<p>FALCON ACRES 14655 DAVIS ROAD</p>	<p>721 S. 23RD ST COLORADO SPRINGS, CO 80904 OFFICE: 719-635-6422 FAX: 719-635-6426 www.fresinc.com</p>		<p>GRADING & EROSION CONTROL PLAN GRADING & EROSION CONTROL PLAN</p>
DESIGNED BY JF			
DRAWN BY JF			
CHECKED BY LD			
H-SCALE AS NOTED			
V-SCALE AS NOTED			
JOB NO. 2142.00			
DATE ISSUED 11/26/21			
SHEET NO. 6 OF 10

GRADING & EROSION CONTROL PLAN
DETAILS SHEET

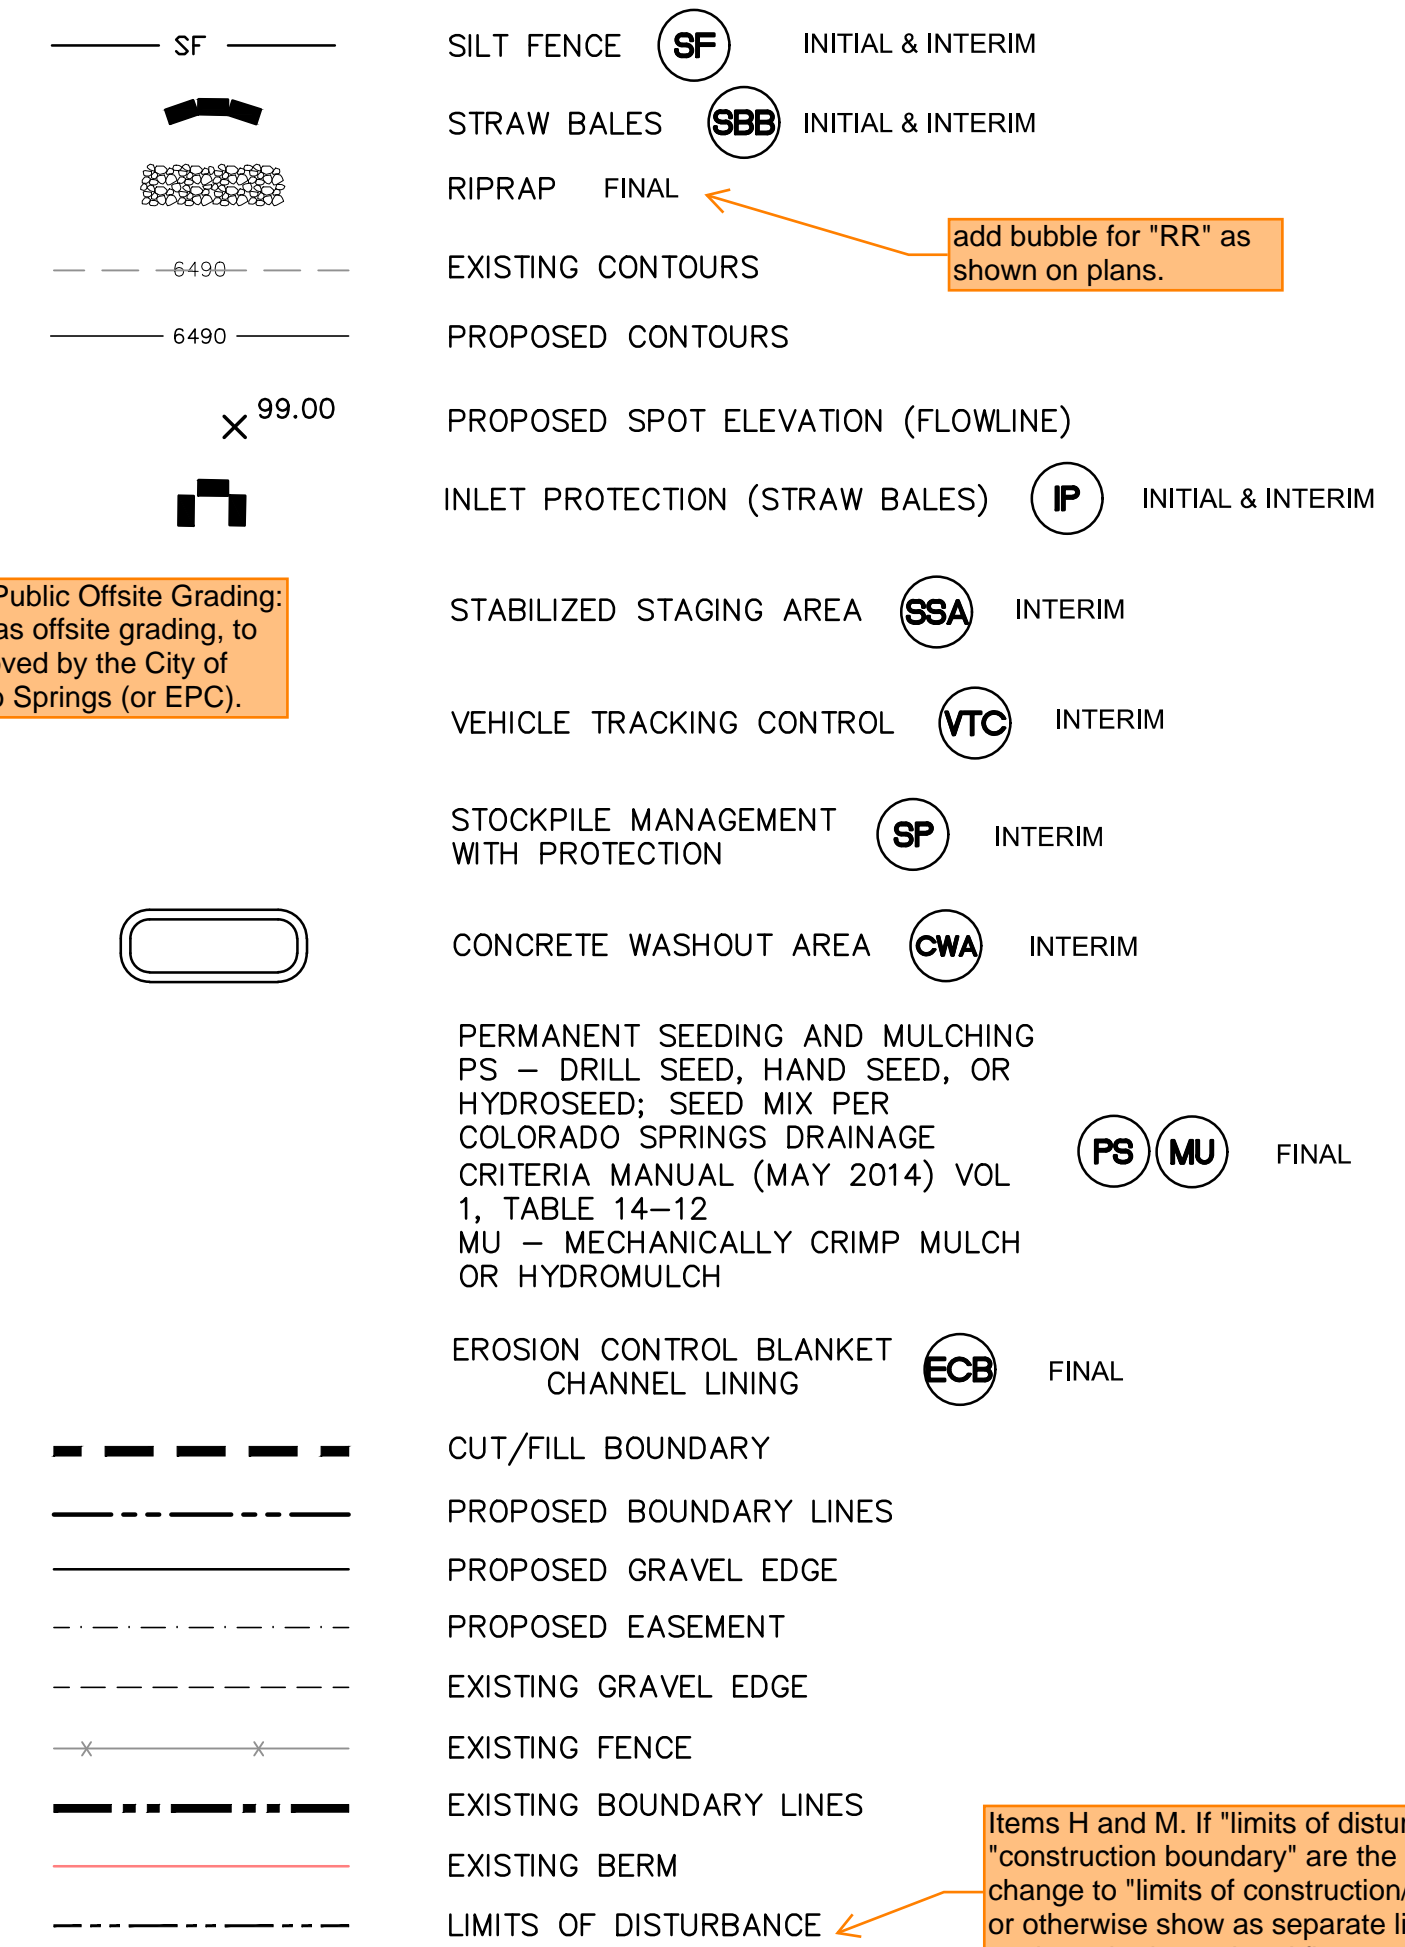
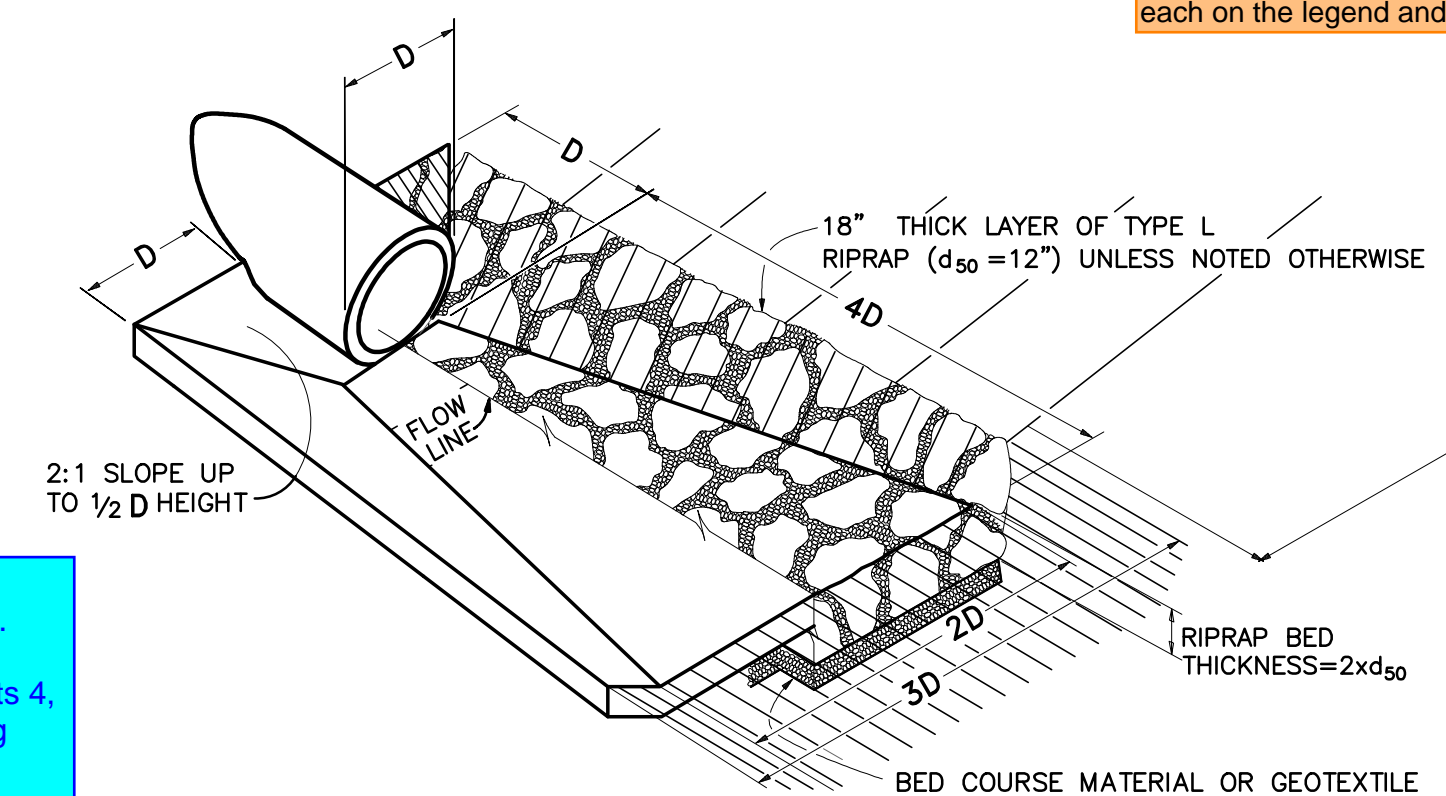
Checklist Item "i" - add a note about condition and type of existing vegetation.
